6 March 2013

**CONCEPT PLAN AND PROJECT APPLICATION FOR STAGE 1 FOR
MIXED USE DEVELOPMENT AT SHEPHERDS BAY, MEADOWBANK (MP09_0216 AND
MP09_0219)**

MAXIMUM NUMBER OF STOREYS ABOVE GROUND LEVEL (FINISHED) AS APPROVED BY THE PLANNING ASSESSMENT COMMISSION (March 2013)

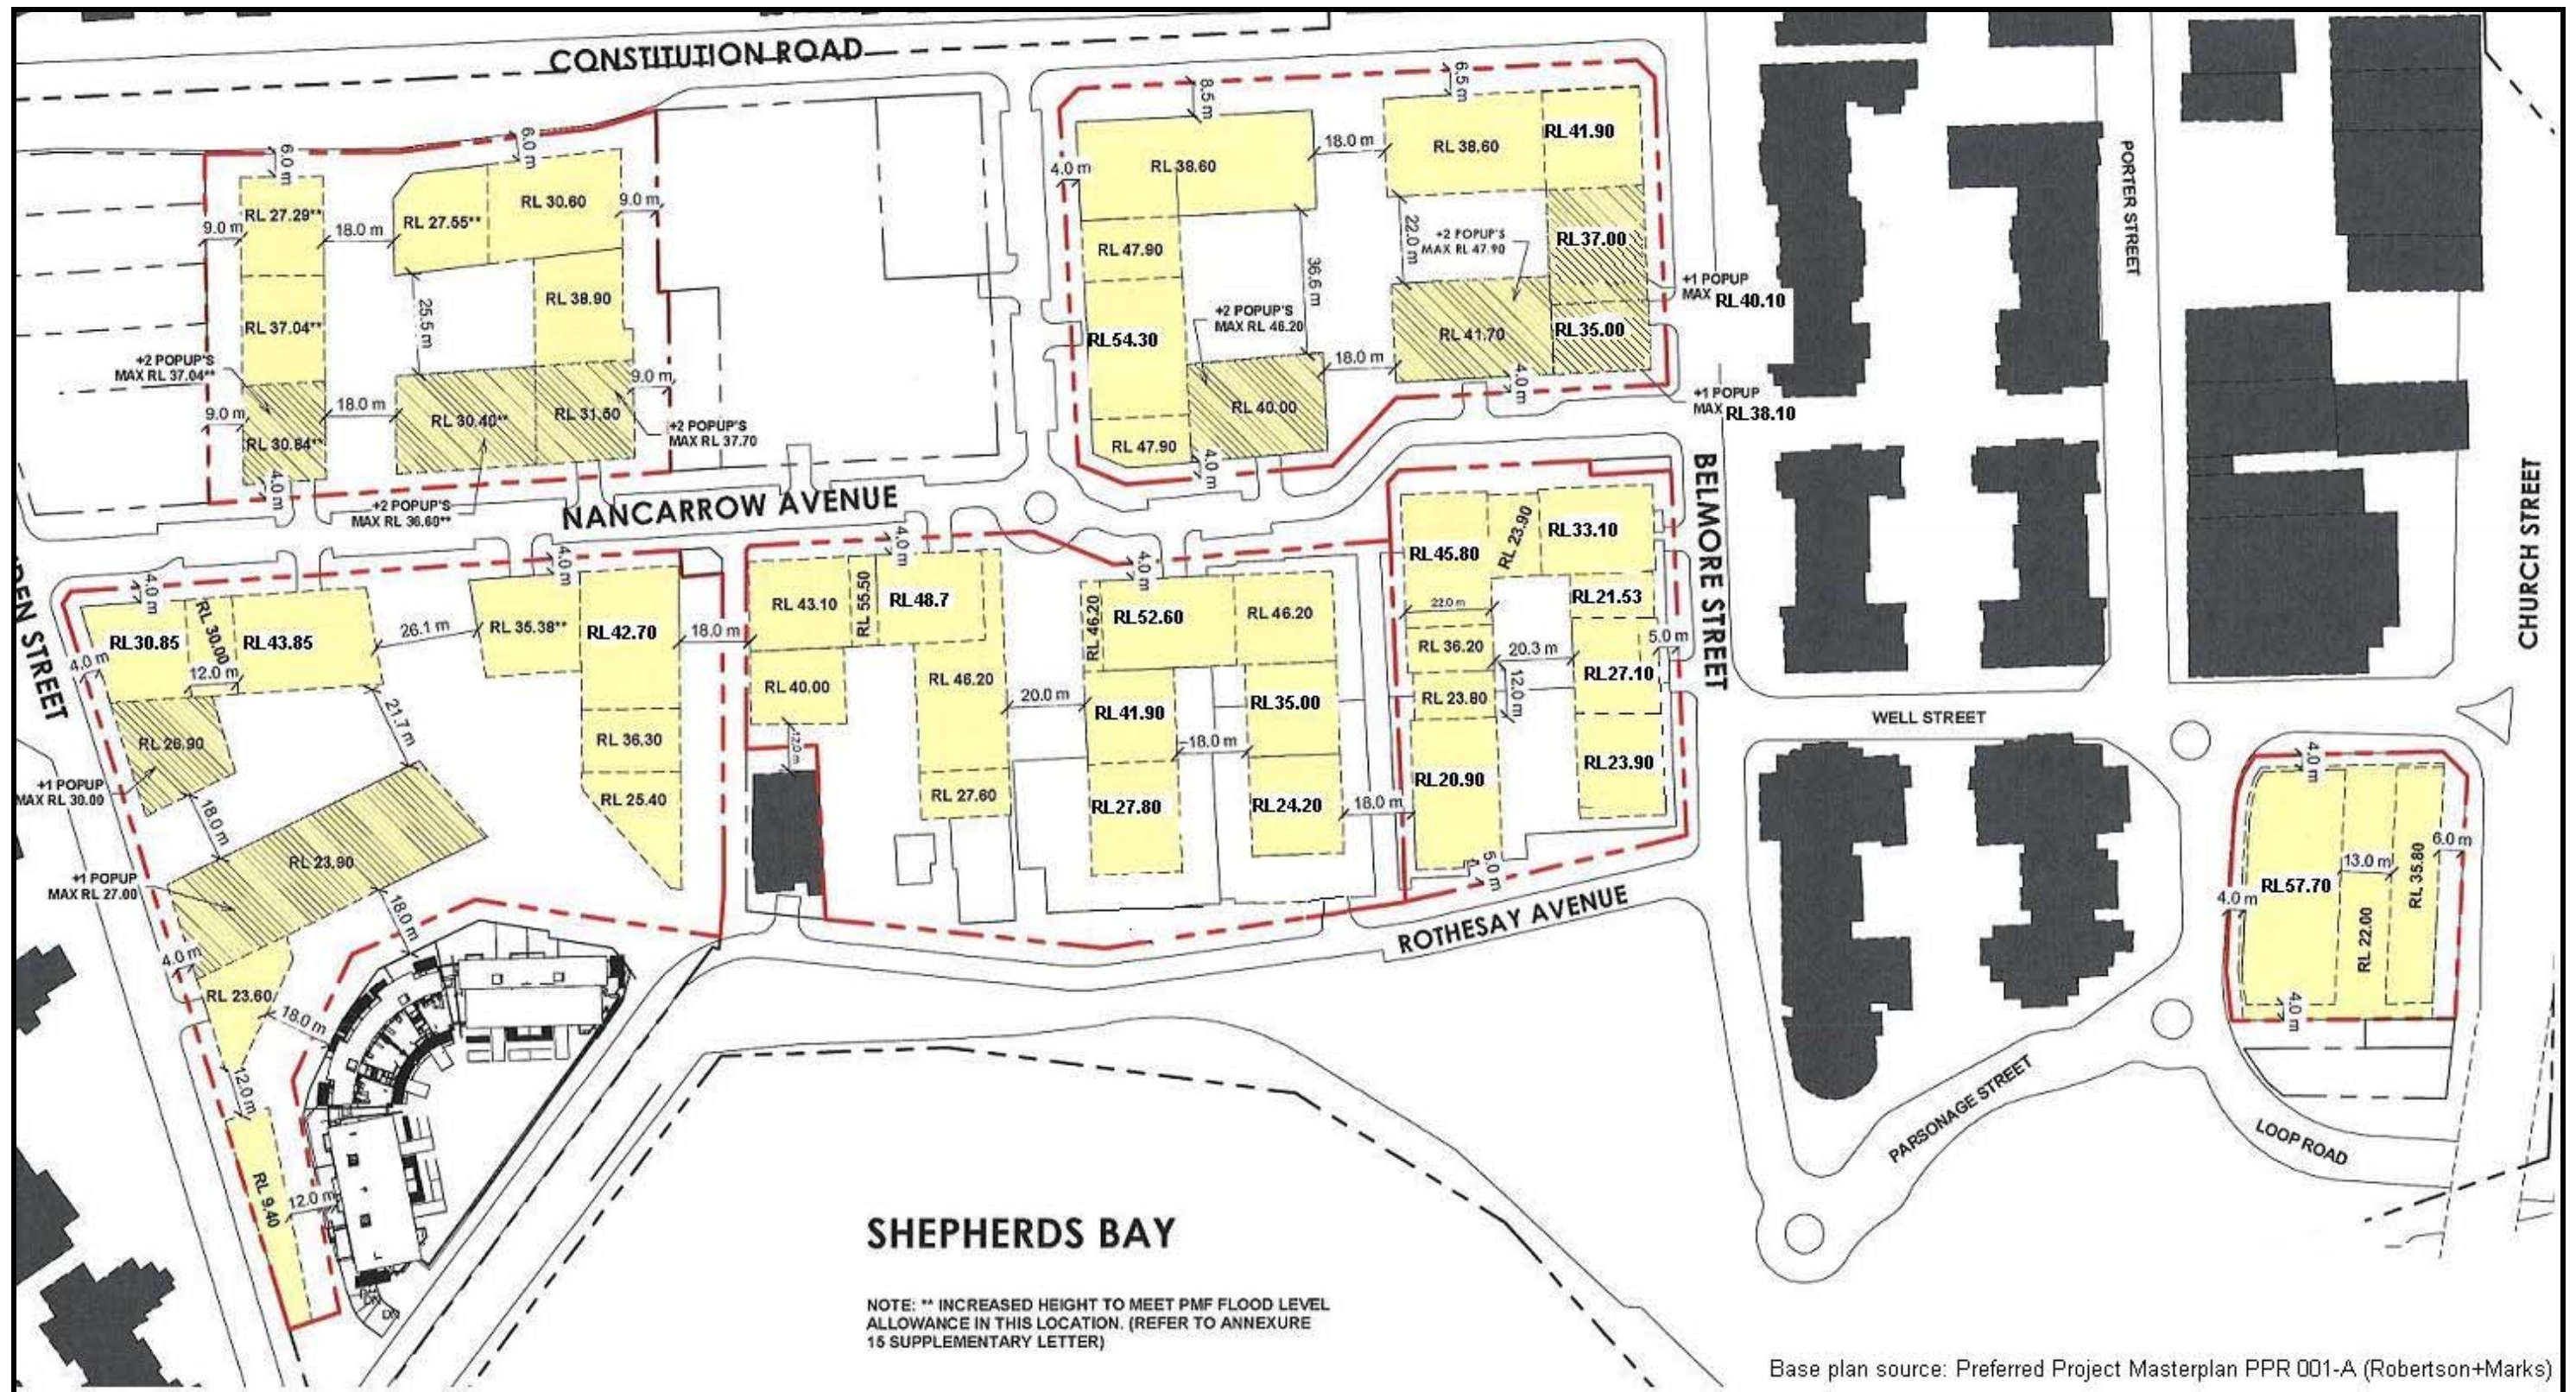
Notwithstanding this, the Commission considers for the reasons above that higher density is possible on this site, but only to a maximum of ten storeys in the centre of the site, and on the separate Church Street site. Where the site interfaces with existing development or the river foreshore, lesser heights are required to ensure an appropriate transition, and to prevent overshadowing. The maximum height plans in Appendix reflect this change and a condition requires the concept plan to be amended and resubmitted to effect this and other modifications.

The Commission considers that given uncertainties in relation to the finished ground levels across the site, it is necessary for a maximum storey plan to be included in the approval. Any development application for future stages will therefore be required to comply with not only the maximum RL (AHD) but also with the maximum number of storeys above finished ground level whichever is the lower. (See Appendix 2)

The Commission notes public concern regarding adherence to the 20m minimum setback from the river foreshore required under the planning controls. The Commission has checked the proposals and found them to comply, however the Commission considers that for Stage 3, a greater setback from the foreshore is required. (See Appendix 2)
